**Mineral Sites Proposed for Allocation through the Bournemouth, Dorset and Poole Mineral Sites Plan**

Site Name and reference:	<b>BS02 Marnhull Quarry, Marnhull</b>
Proposed development:	Extraction and processing of building stone
Lead Local Flood Authority comments:	<p>BS02 Marnhull Quarry extension Site Assessment</p> <p>No grounds for objection, subject to detail: The site falls within Flood Zone 1 (low risk – fluvial flooding) according to the Environment Agency’s relevant flood modelling. Equally the site is not shown to be at theoretical risk of surface water flooding, by relevant mapping, although it is within 200m (west) of significant flood risk (both fluvial &amp; surface water ) associated with a tributary of the Main River Stour (Chilvrick’s Brook – Ordinary Watercourse).</p> <p>Whilst the site would appear to be elevated well above this flood risk, a site specific strategy for surface water management should be requested to ensure that proposed land use does not exacerbate such risk downstream. As such the proposed activity should comply with the recommendations of the NPPF. Prior Land Drainage Consent may be required from DCC as relevant LLFA, for any works offering

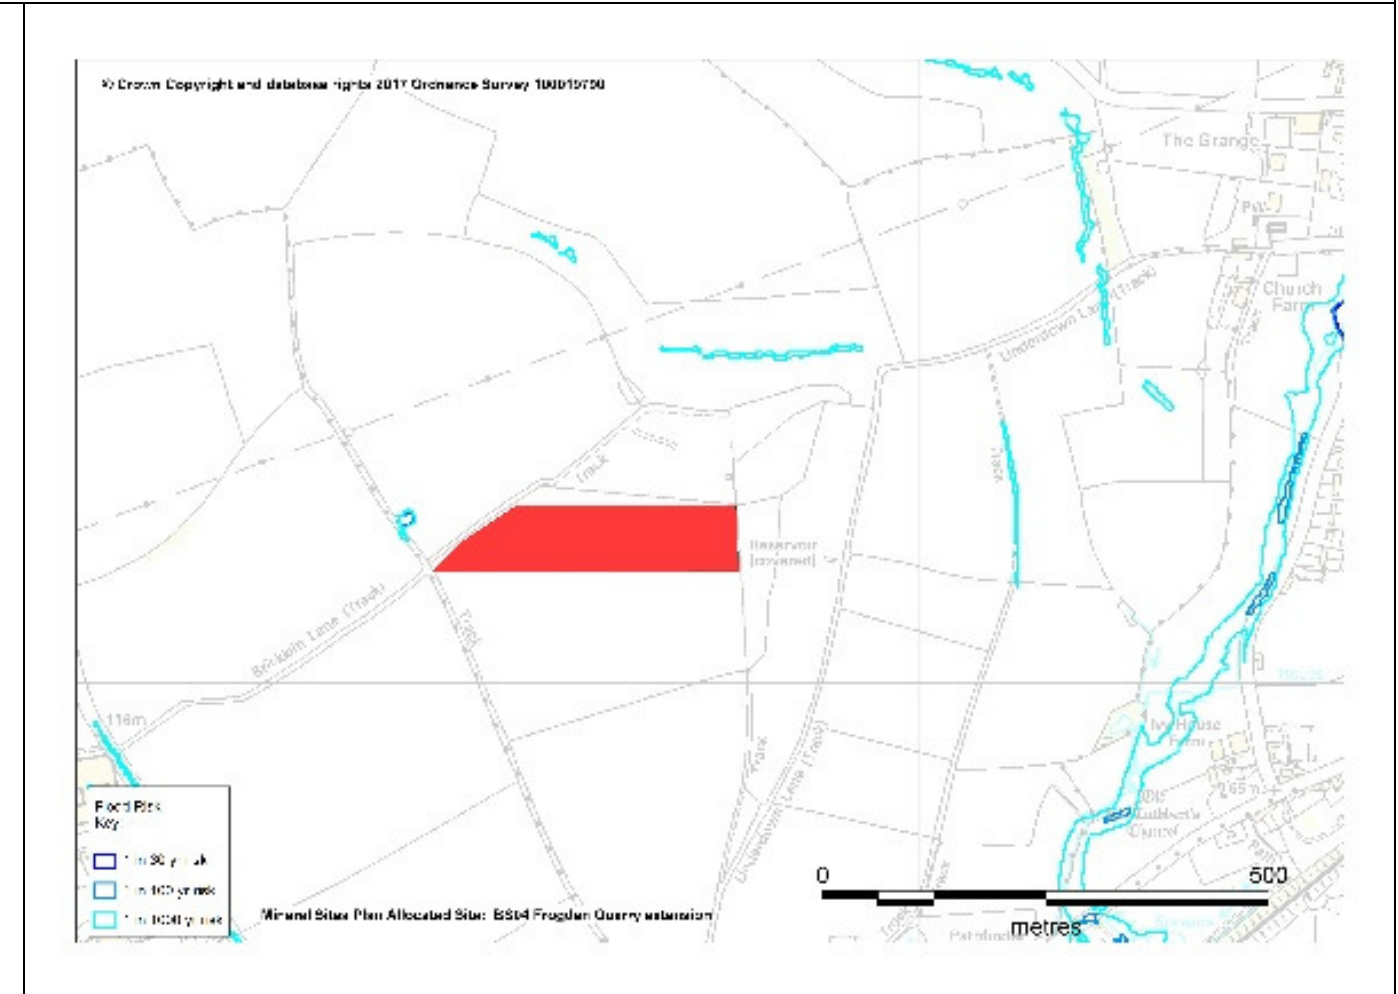
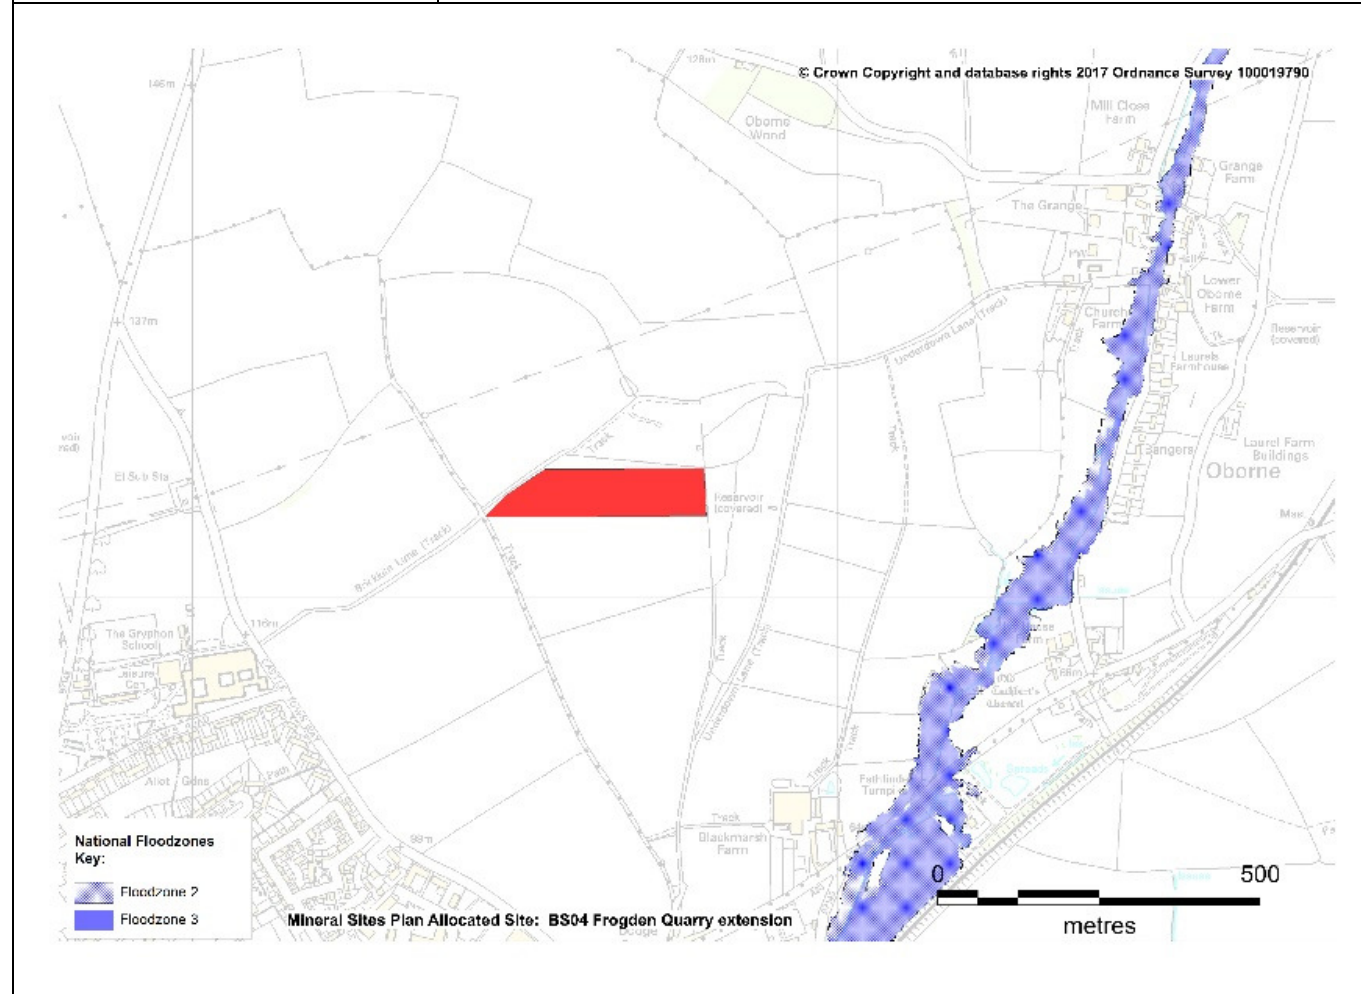
Site Name and reference:	<b>BS04 Frogden Quarry Extension, Sherborne</b>
Proposed development:	Extraction and processing of building stone
Lead Local Flood Authority comments:	<p>BS04 Frogden Quarry extension Site Assessment</p> <p>No grounds for objection, subject to detail: The site falls within Flood Zone 1 (low risk – fluvial flooding) according to the Environment Agency’s relevant flood modelling. Equally the site is not shown to be at theoretical risk of surface water flooding, by relevant mapping.</p> <p>As an elevated site, situated above and north east of Sherborne, the site / proposed use should be supported by specific strategy for surface water management to ensure that proposed activity does not create or exacerbate off site worsening. As such the proposed activity should comply with the recommendations of the NPPF. Prior Land Drainage Consent may be required from DCC as relevant LLFA, for any works offering an obstruction to flow within a channel or ditch with the status of Ordinary Watercourse.</p>

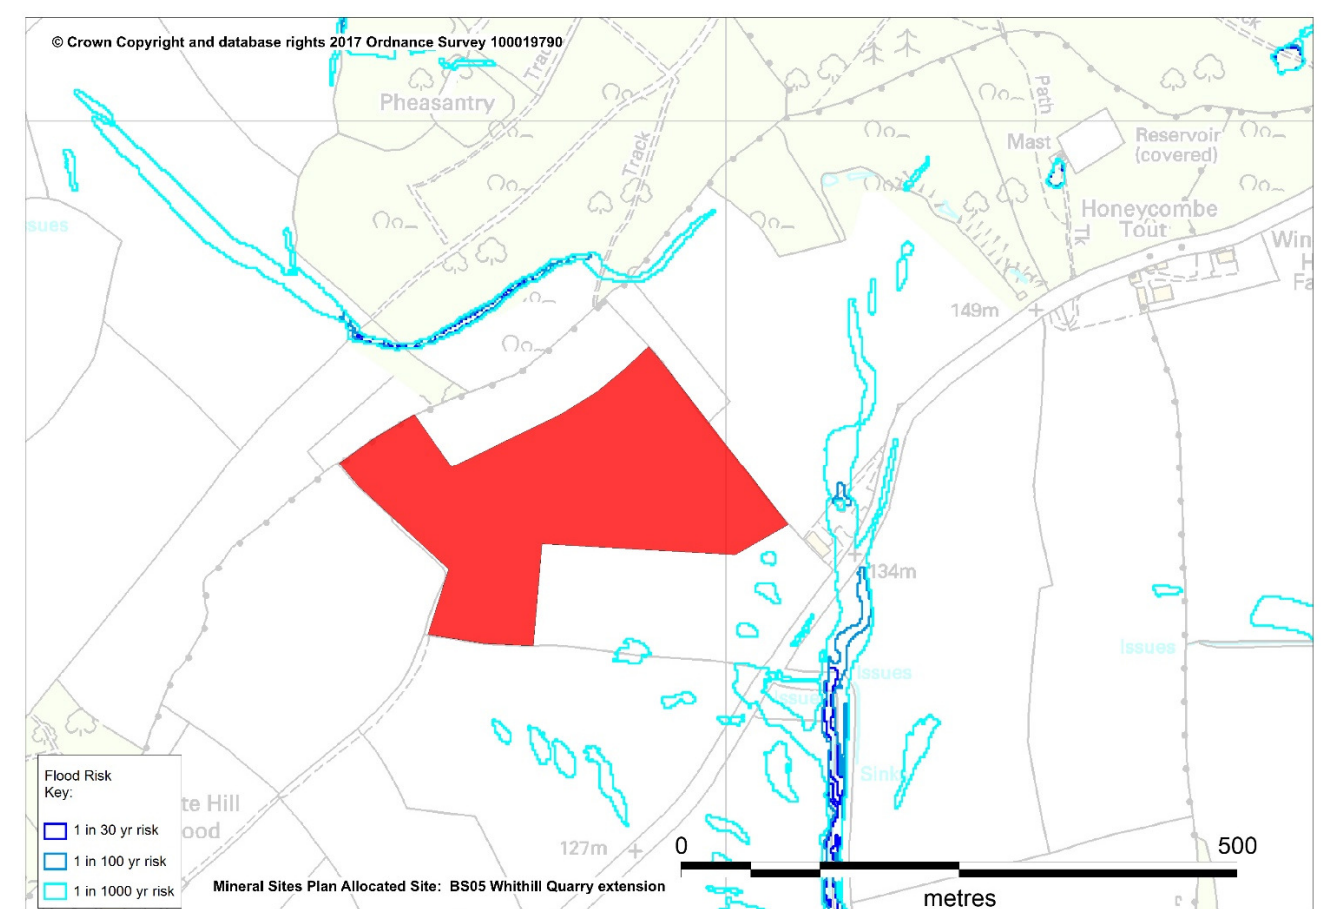
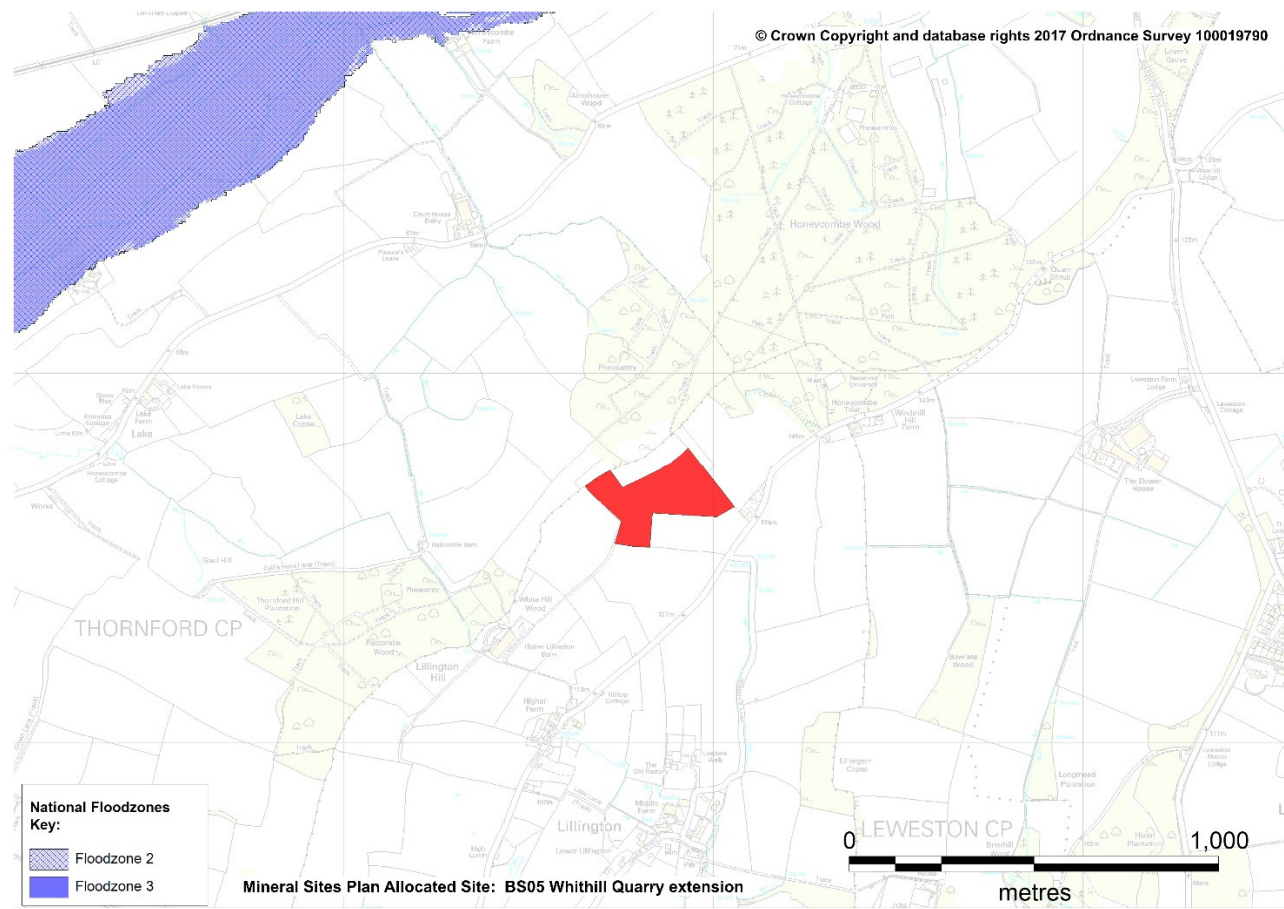
Site Name and reference:	<b>BS05 – Whithill Quarry Extension, Sherborne</b>
Proposed development:	Extraction and processing of building stone
Lead Local Flood Authority comments:	<p>BS05 Whithill Quarry extension Site Assessment</p> <p>No grounds for objection, subject to detail: The site falls within Flood Zone 1 (low risk – fluvial flooding) according to the Environment Agency’s relevant flood modelling. Equally the site is not shown to be at theoretical risk of surface water flooding, by relevant mapping. However, as an elevated site, situated above and north of Lillington, the site generates runoff which enters the watercourse flowing south along Gordon’s Lane. To this end the proposed use has the potential to alter runoff rates.</p> <p>Any proposal should be supported by specific strategy for surface water management to ensure that proposed activity does not create or exacerbate off site worsening. As such the proposed activity should comply with the recommendations of the NPPF. Prior Land Drainage Consent may be required from DCC as relevant LLFA, for any works offering an obstruction to flow within a channel or ditch with the status of Ordinary Watercourse.</p>

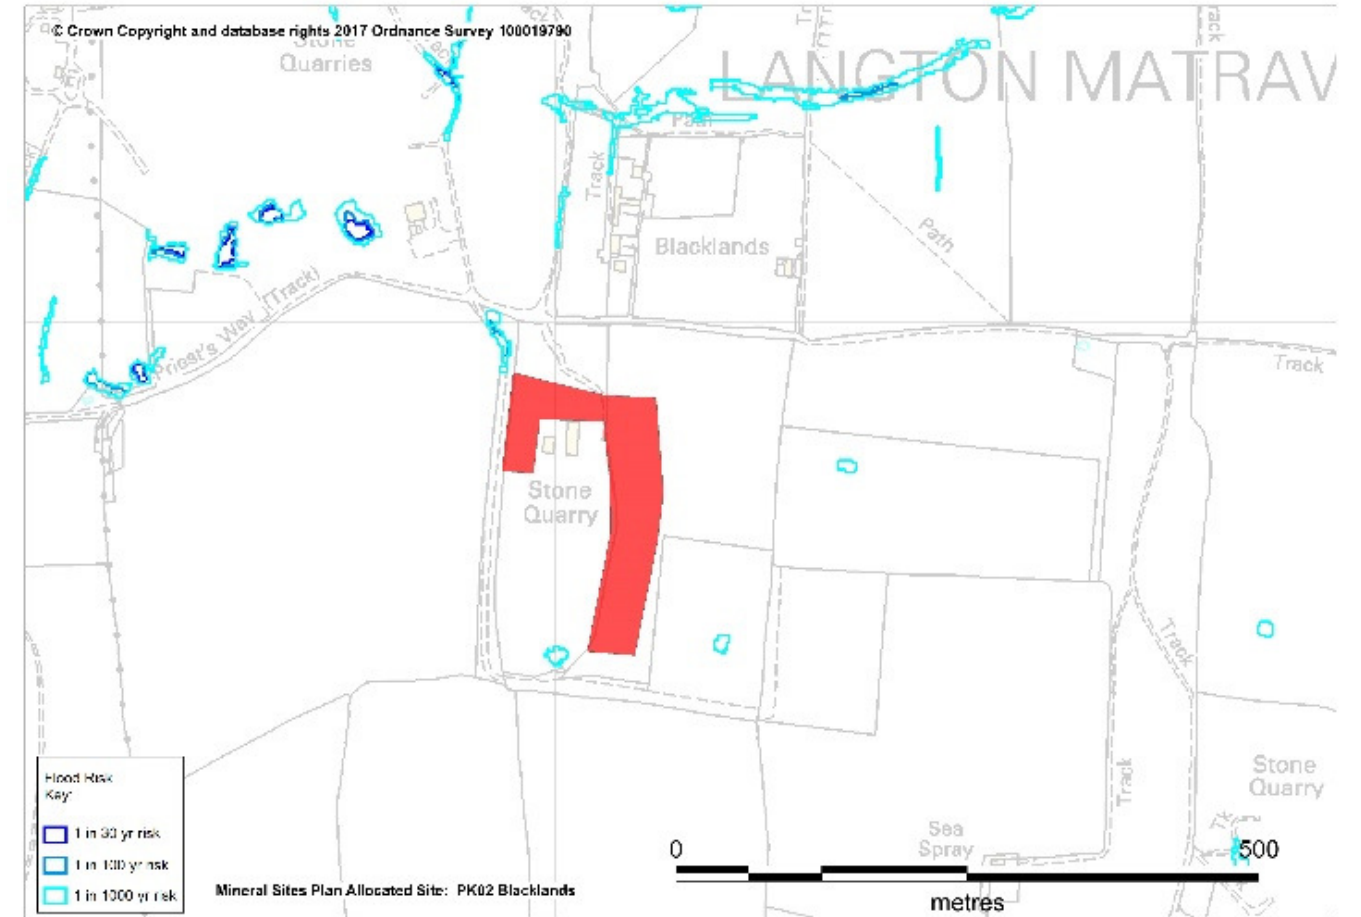
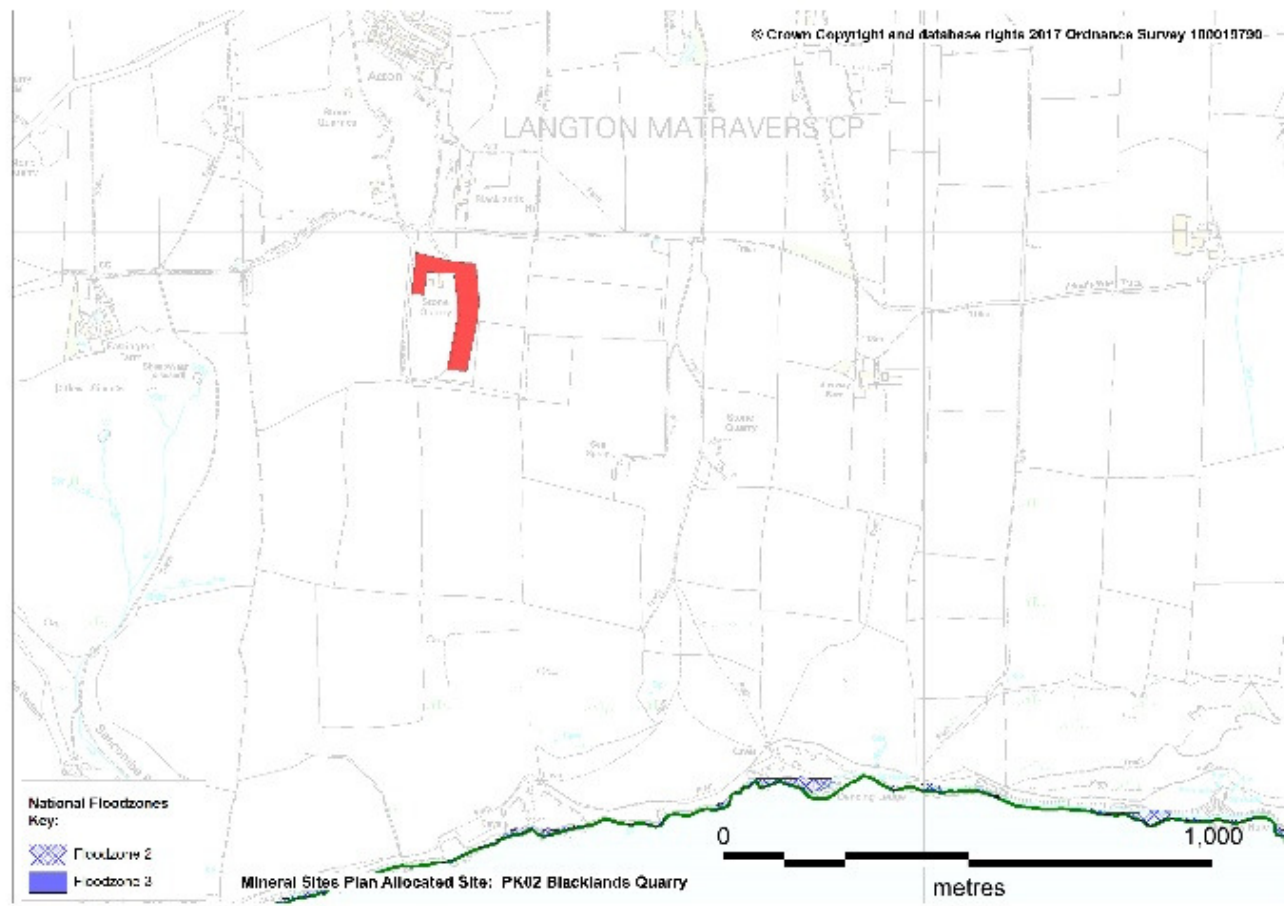
Site Name and reference:	<b>PK02 – Blacklands Quarry Extension, Langton Matravers</b>
Proposed development:	Extraction of Purbeck Stone
Lead Local Flood Authority comments:	<p>PK02 Blacklands Quarry extension Site Assessment</p> <p>No grounds for objection, subject to detail: The site falls entirely within Flood Zone 1 (low risk – fluvial flooding) according to the Environment Agency’s relevant flood modelling, and is not shown to be at any theoretical risk of surface water flooding, by relevant mapping. Given the prevailing geology and fall in ground levels, it is likely that surface water would be managed via infiltration.</p> <p>Whilst a site specific strategy for surface water management is a requirement for all development (NPPF) no off site worsening is anticipated. Prior Land Drainage Consent may be required from DCC as relevant LLFA, for any works offering an obstruction to flow within a channel with the status of Ordinary Watercourse.</p>

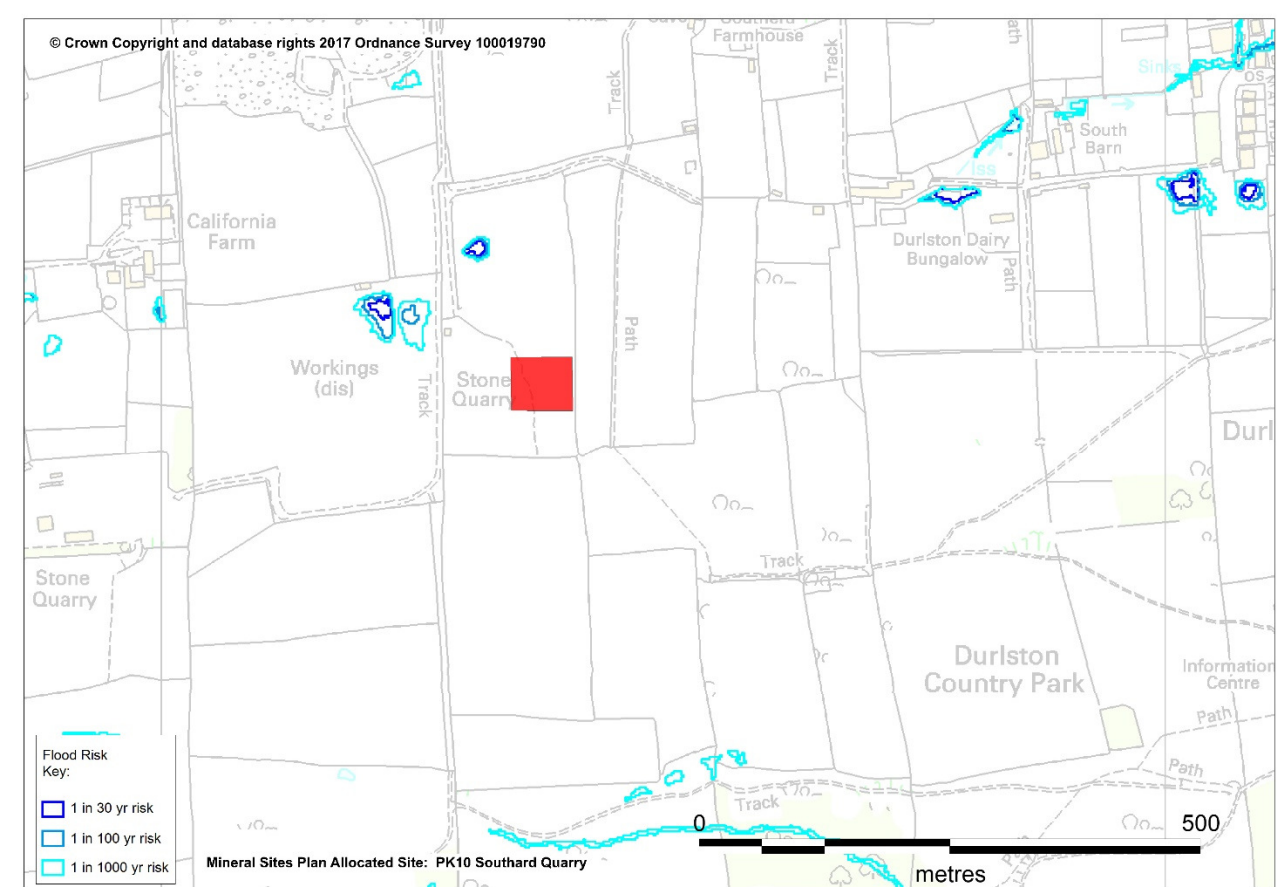
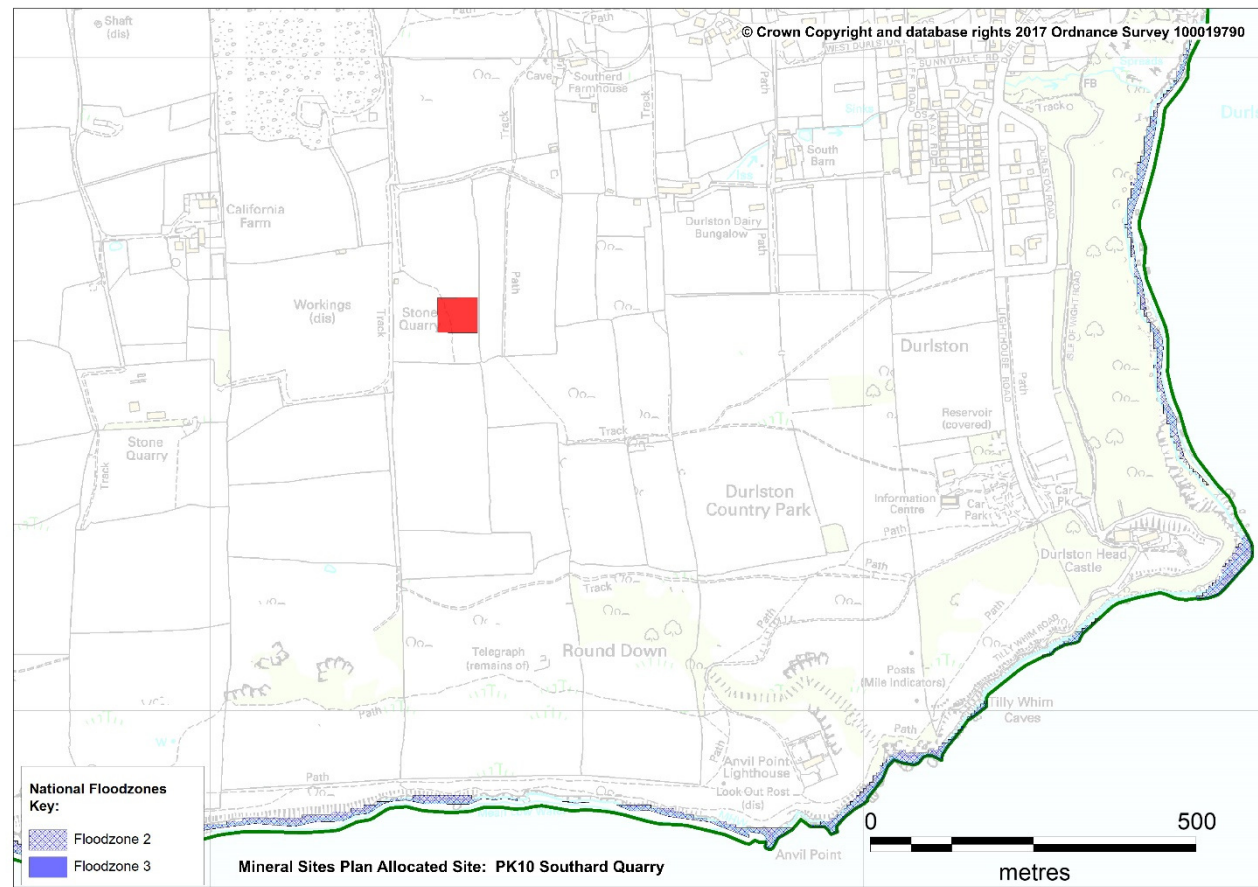
Site Name and reference:	<b>PK10 – Southard Quarry, Swanage</b>
Proposed development:	Extraction of Purbeck Stone
Lead Local Flood Authority comments:	<p>PK10 Southard Quarry extension Site Assessment</p> <p>No grounds for objection, subject to detail: The site falls entirely within Flood Zone 1 (low risk – fluvial flooding) according to the Environment Agency’s relevant flood modelling, and is not shown to be at any theoretical risk of surface water flooding, by relevant mapping. Given the prevailing geology and fall in ground levels, it is likely that surface water would be managed via infiltration. However this may require verification from Purbeck DC in-light of their policy against the use of soakaways / infiltration in proximity to the cliffs at Durlston, to the east.</p>
